TO: Mercedes-Benz Dealer Principals, General Managers, Sales Managers, Service Managers, Parts Managers	FROM: Gregory Gunther, Senior Manager, Vehicle Compliance and Analysis, Engineering Services
RE: Service Campaign Launch Notification Replace Rear Axle Flex Disk and Install Additional Heat Shield MY20-24 CLA and GLA (118 and 247 platform)	DATE: December 13, 2024

Campaign No. 2024110007, December 2024

SUBJECT: **Model CLA & GLA (118 and 247 platform)**
Model Year 2020 – 2024

Replace Rear Axle Flex Disk and Install Additional Heat Shield

Figure 1

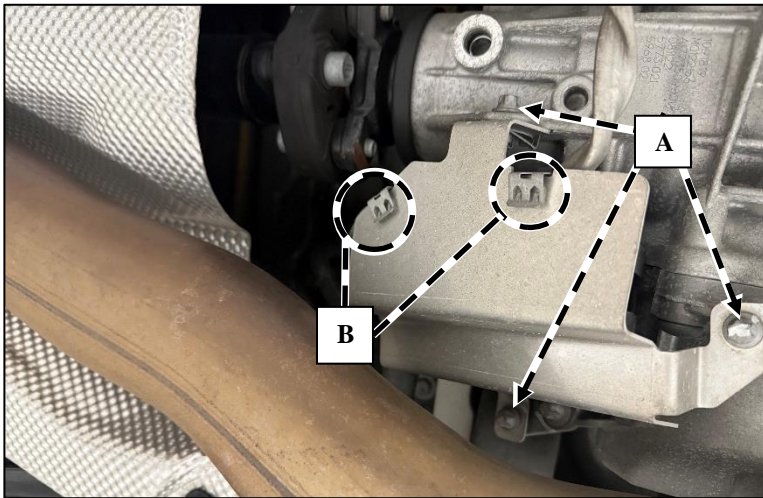
3.1 Remove the existing heat shield. The old heat shield is no longer required.

i To do so, remove the 3 hexalobular bolts (**Figure 1, A**) and 2 electrical harness retaining clamps (**Figure 1, B**).

i The new heat shield is comprised of two pieces. First, install the bigger metal sheet – which has the two sheet metal nuts – in the same place as where the old one was installed. To do so, use three new N 910143 006000 screws.

Figure 1

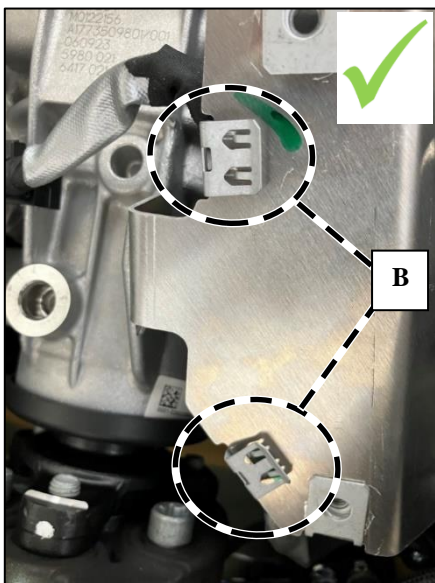
3.2 Next, reattach the 2 electrical wiring harness retaining clamps (**Figure 2, B**).

i Important: During attachment, make sure that the electrical wiring harness is above the cover sheet.

Figure 2

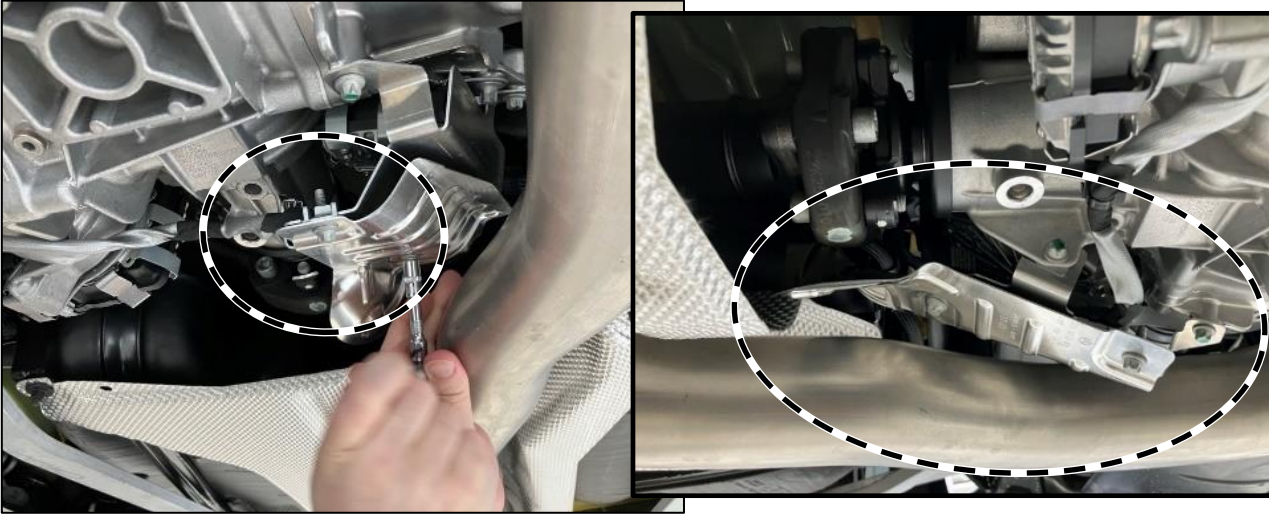
3.3 Install the additional heat shield cover.

i Mount the heat shield on the sheet metal nuts for the new cover sheet using the two N 910143 006001 hexalobular bolts (**Figure 3**).
